Access Compliance Report

Public Rights-of-Way

(Curb Ramps)

Intersection ID: 3679	Main Street: BRIDLE_RIDGE_LN	Cross Street: DAVIS_LAKE_PY	Location: NE
ADA ID: 8B85BE52A13B	Ramp Type: Perp	Initial Pass/Fail: Fail	Overall Compliance: No
Codes/Mitigation Info/Possible Solution		Field Measurements/Component Compliance

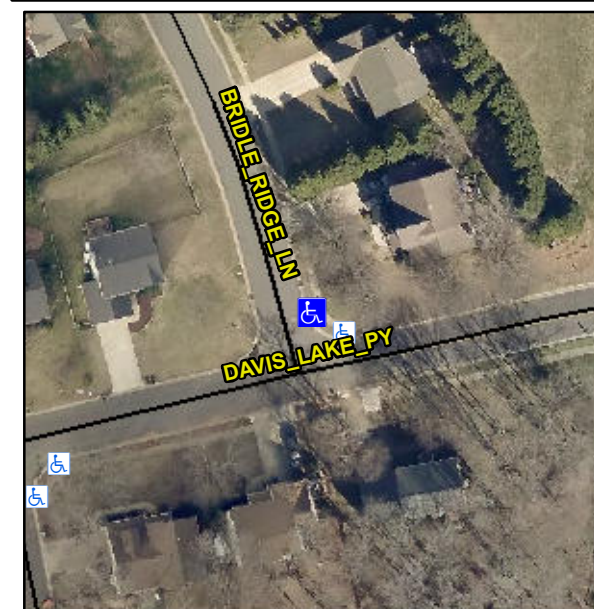
Not Found, R304.5.1, R304.5.3

Compliance	Description	Data	Compliance	Description	Data
N/A	Ramp Length (in)	49.0	Yes	Ramp Slope (%)	5.7
No	Ramp Width (in)	42.5	No	Ramp XSlope (%)	3.8
N/A	Flare Type LT	N/A	N/A	Flare Type RT	N/A
N/A	Flare Slope LT (%)	N/A	N/A	Flare Slope RT (%)	N/A
N/A	Flare Traversable LT?	N/A	N/A	Flare Traversable RT?	N/A
N/A	Landing Length (in)	N/A	N/A	DWS Provided?	N/A
N/A	Landing Width (in)	N/A	N/A	DWS Contrast?	N/A
N/A	Landing Slope (%)	N/A	N/A	DWS Length (in)	N/A
N/A	Landing X Slope (%)	N/A	N/A	DWS Full Width?	N/A
N/A	Landing Curb? (Y/N)	N/A	N/A	DWS Offset (in)	N/A
N/A	Shared Landing?	N/A			
N/A	Gutter Ponding?	N/A	N/A	Gutter Slope (%)	N/A
N/A	Gutter Lip Ht (in)	N/A	N/A	Gutter X Slope (%)	N/A
N/A	Painted X Walk1?	No	N/A	Painted X Walk2?	N/A
	X Walk 1 Direction	To W		X Walk 2 Direction	N/A
N/A	X Walk 1 Width (in)	N/A	N/A	X Walk 2 Width (in)	N/A
	X Walk 1 Slope (%)	2.0		X Walk 2 Slope (%)	N/A
	X Walk 1 X Slope (%)	3.5		X Walk 2 X Slope (%)	N/A

Remove & Replace Entire Ramp.
